# PROPOSED CHANGES APPLICATION REPORT

## Drax Bioenergy with Carbon Capture and Storage

**Document Reference Number: 8.5.1**

**Applicant: Drax Power Limited**

## Plate 2-2 - Proposed Changes to Order Limits (PC-01 – FCA)

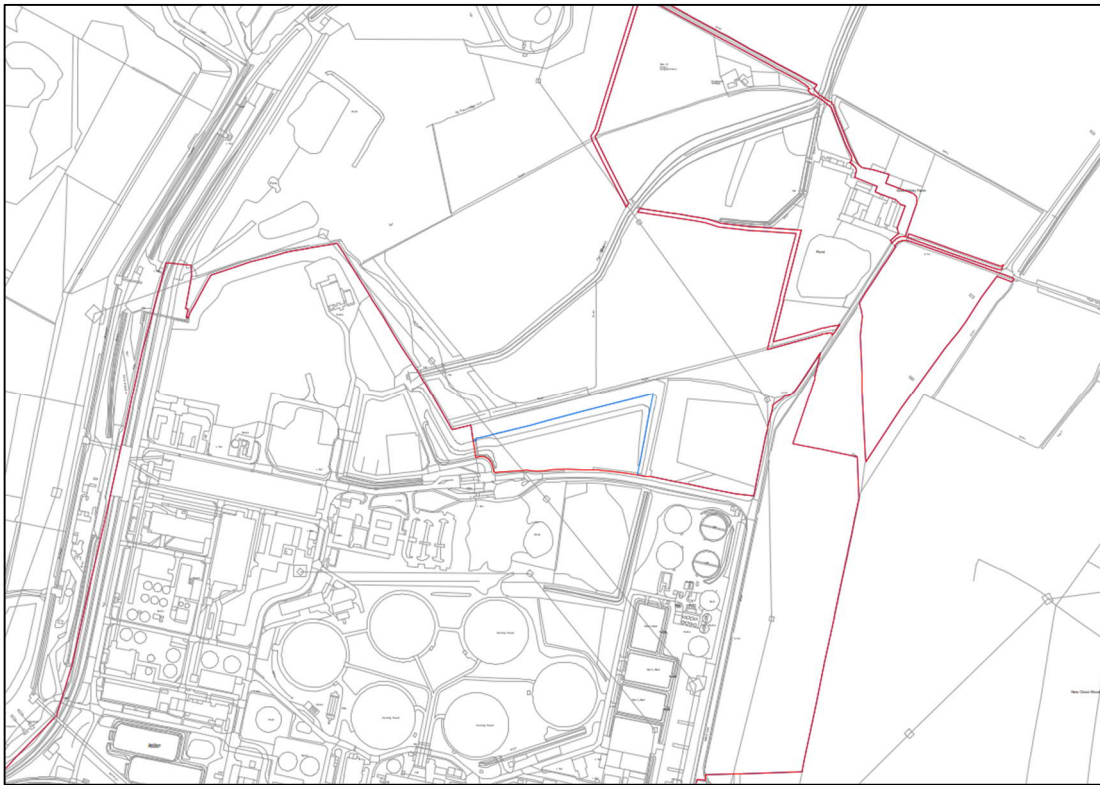
- 2.2.3. The land required for PC-01, to provide the FCA, is shown in more detail in Plate 2-2, and is located immediately to the north of the Drax Power Station Site boundary fence and comprises a field with undulating topography, but with a general sloping gradient from higher ground levels towards the southern edge of the field and lower levels to the north.

## Plate 2-5 – Works Plans including the Proposed Changes

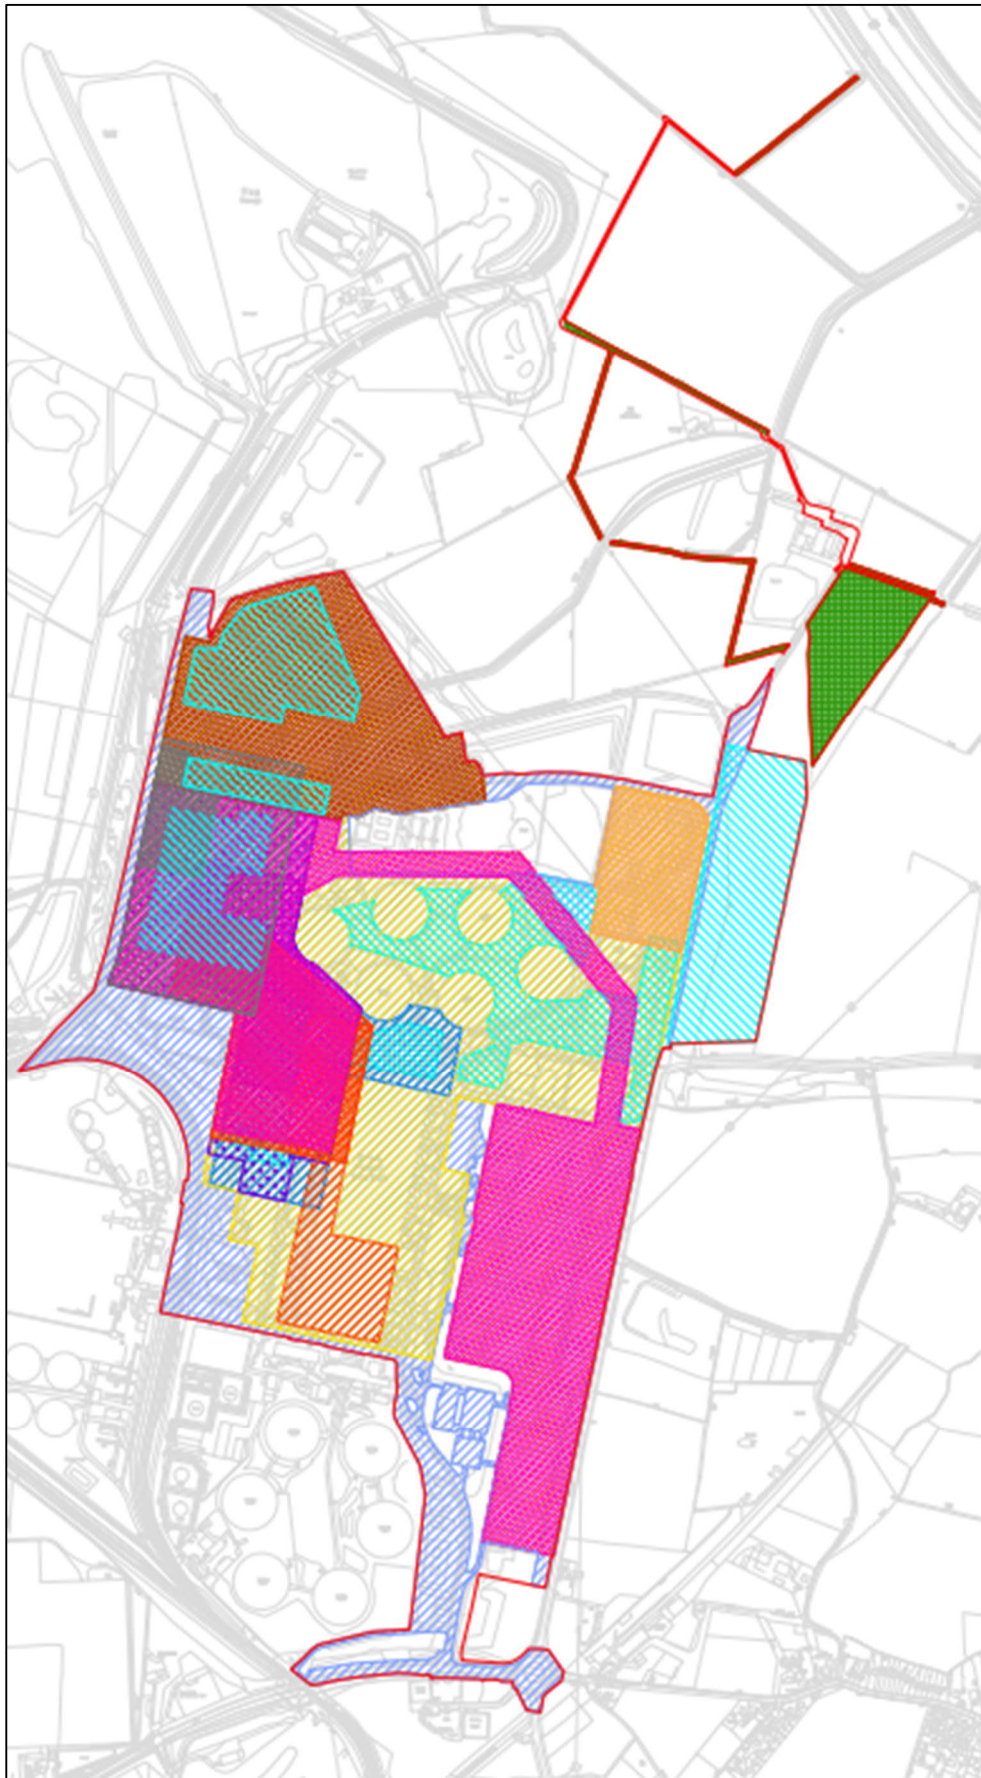
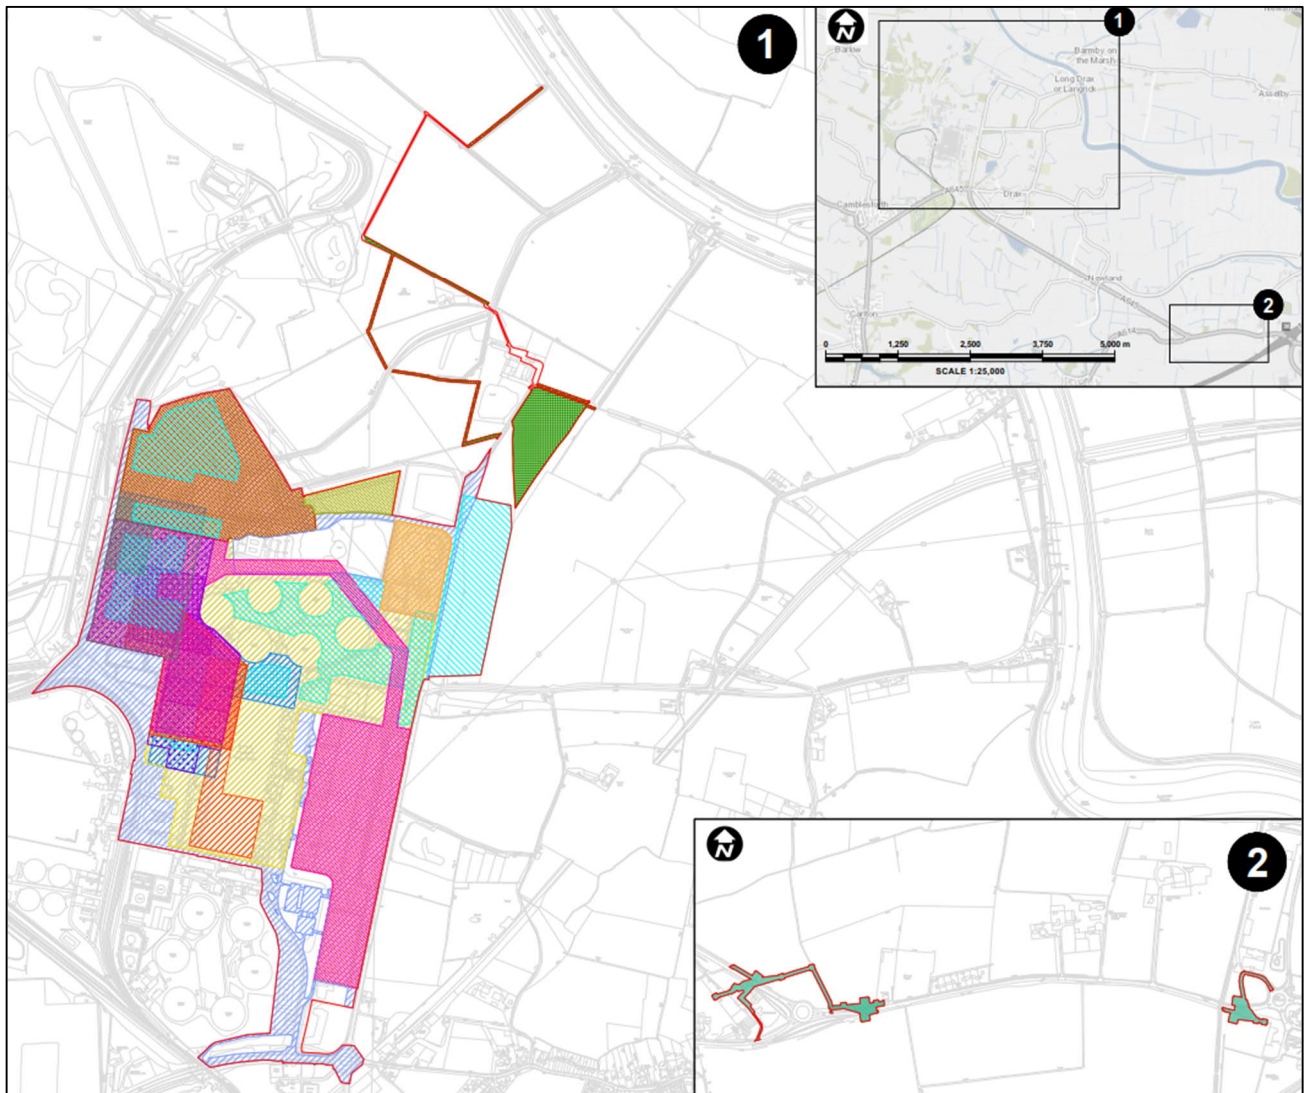
- 2.2.5. Plates 2-4 and 2-5 show relevant extracts of the previous (Plate 2-4) and revised (Plate 2-5) Works Plans illustrating the Proposed Changes. Extracts of changes to Works Plans arising from the Proposed Changes are provided at Appendix 10, document reference 8.5.3.10.

## Plate 6-1 - Drawing Showing Location of OHL1 and TCL1

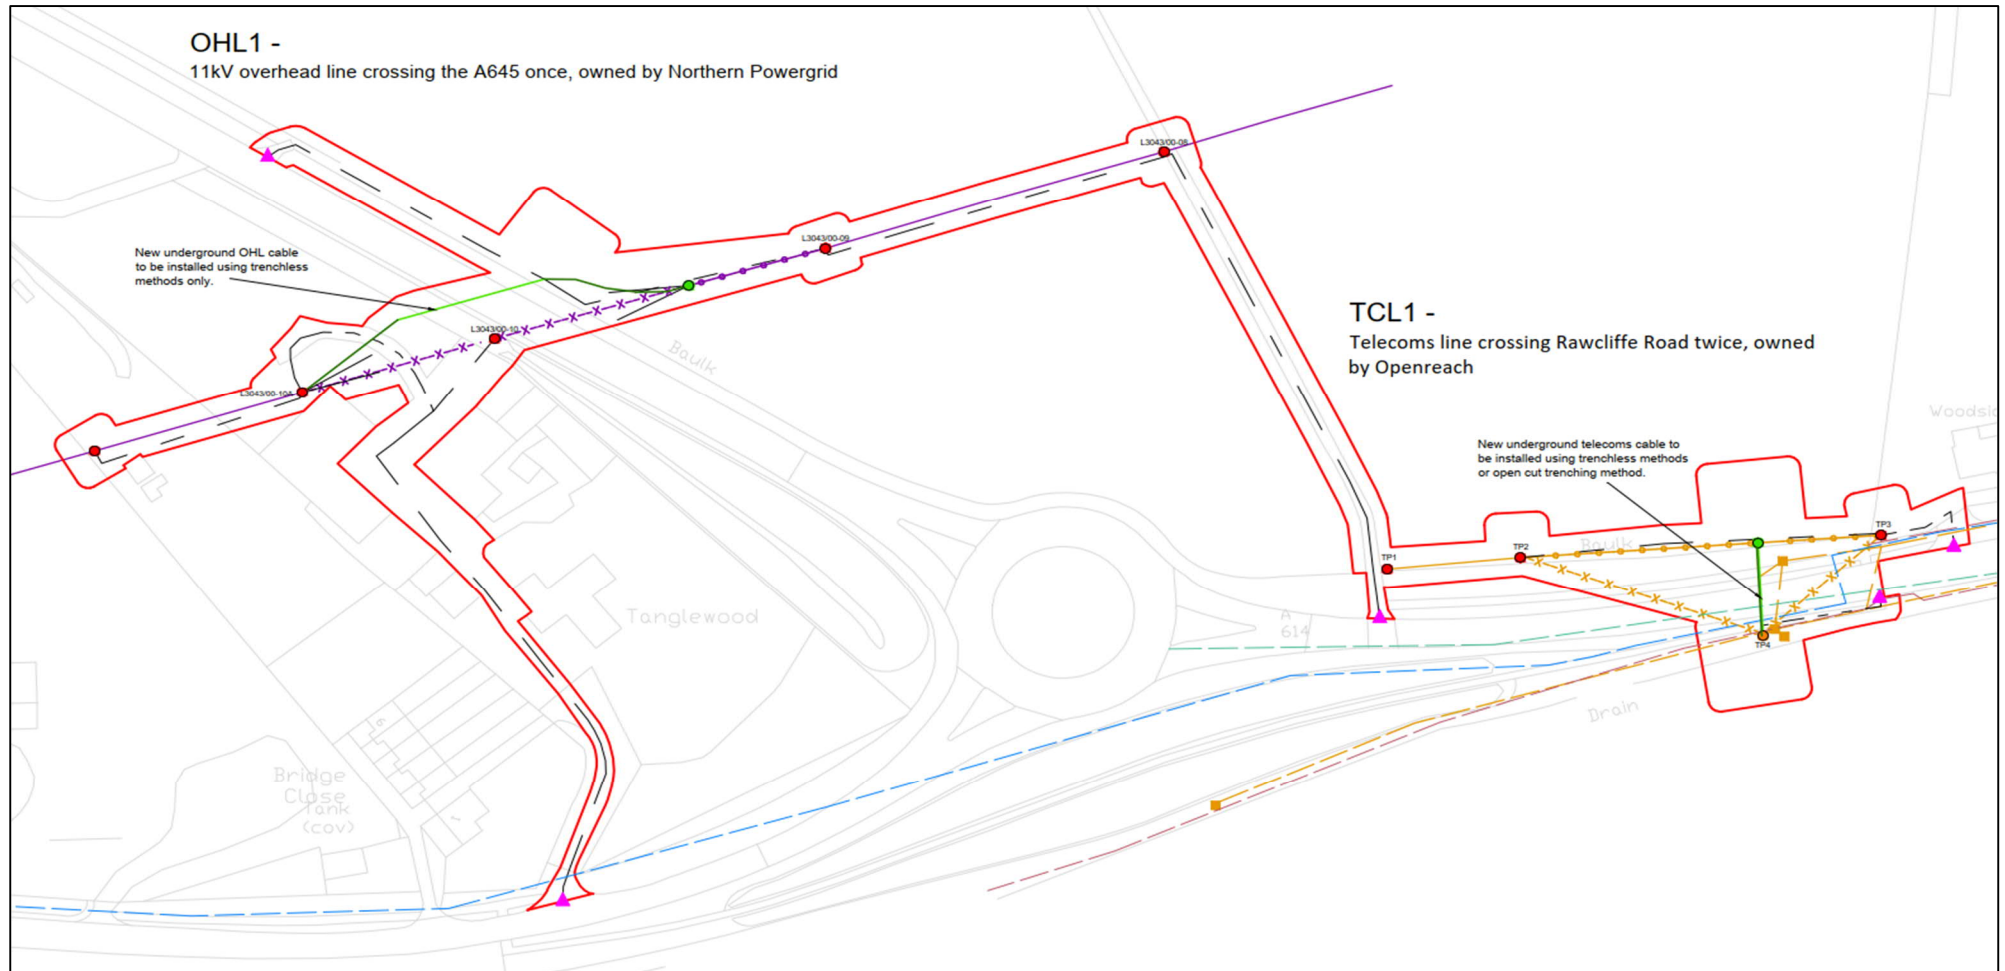
- 6.1.1. Two electrical 11kV overhead lines (OHL1 and OHL2) and the telecommunications line (TCL1) ('the Lines') currently cross the proposed AIL route from the Port of Goole to Drax Power Station, north of the M62. The locations of these Lines are shown on Plates 6-1 and 6-2, which show indicative designs and illustrative layouts.

Plate 6-3 – Plan showing Proposed Areas of Works for HDD (OHL1 and TCL1)

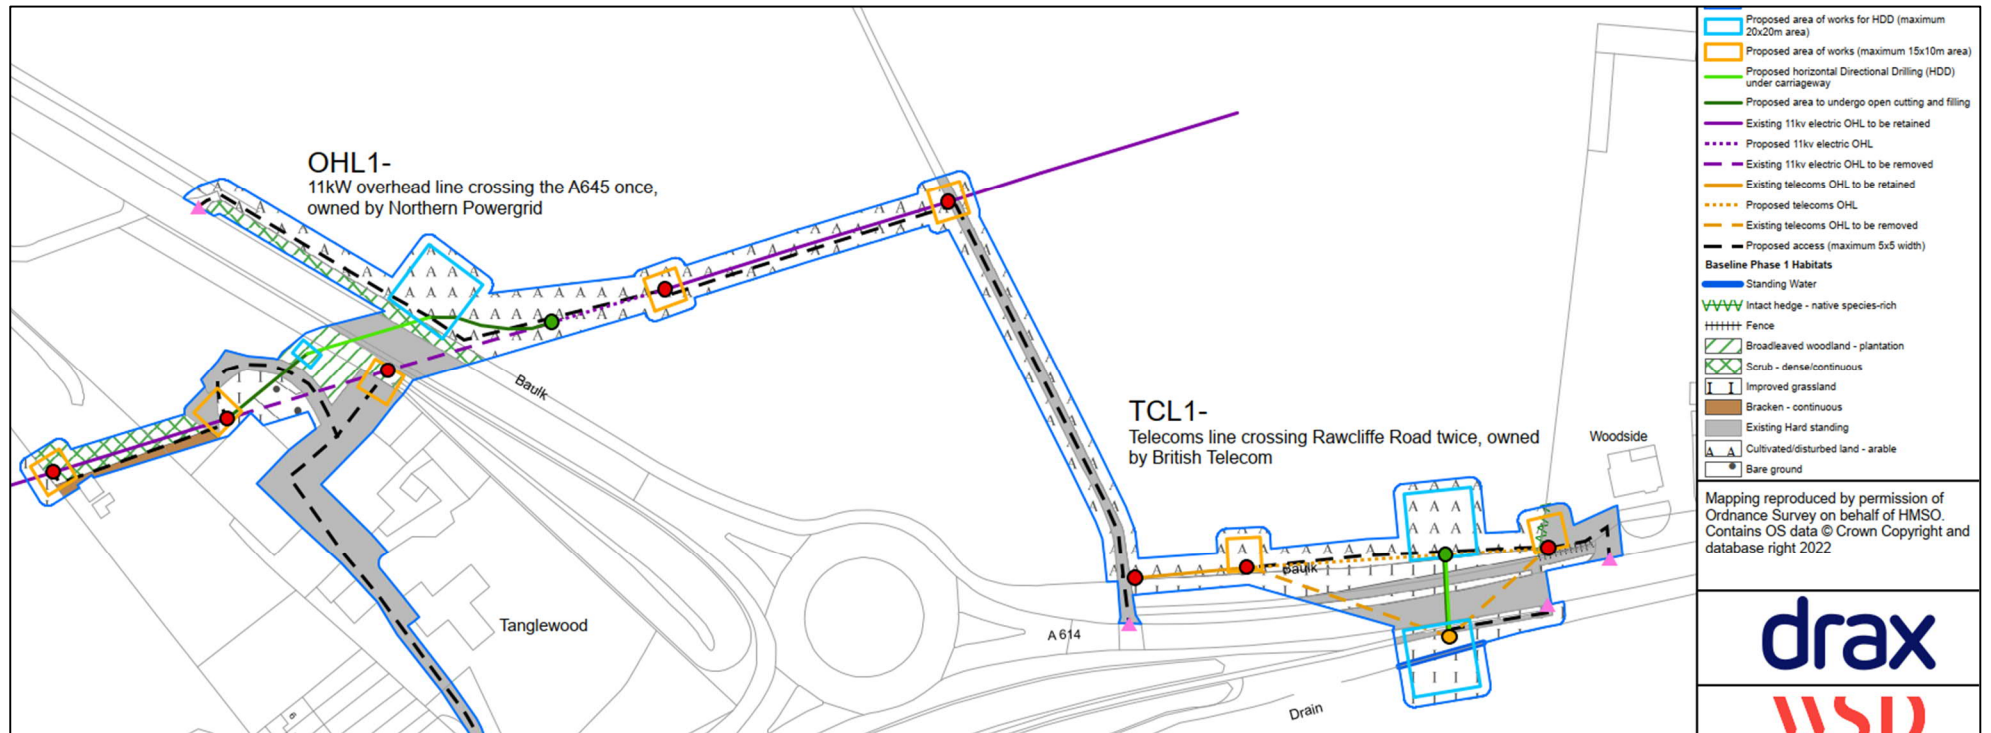
- 6.1.14. To facilitate the works, a small working compound would be set up for each of the lines as shown in Plates 6-3 and 6-4. It is anticipated that these working compounds would be 20m x 20m for the Driving Compound. The working compounds would be suitably fenced using, for example, Heras fencing and would be used to provide the working area for the HDD rig, a self-contained welfare unit and materials storage. Materials such as cabling and duct work would be delivered "just in time" before the works. A smaller area would be required for the Receptor Compounds which would be approximately 5m x 7m. However, to provide flexibility for the Driving and Receptor Compounds at either end of the HDD until full details are known, a maximum compound size of 20m x 20m has been provided for within the revised Order Limits at each end of a proposed HDD section.

- 6.1.15. For **OHL1** the HDD Driving Compound and Receptor Compound have been defined due to existing constraints.
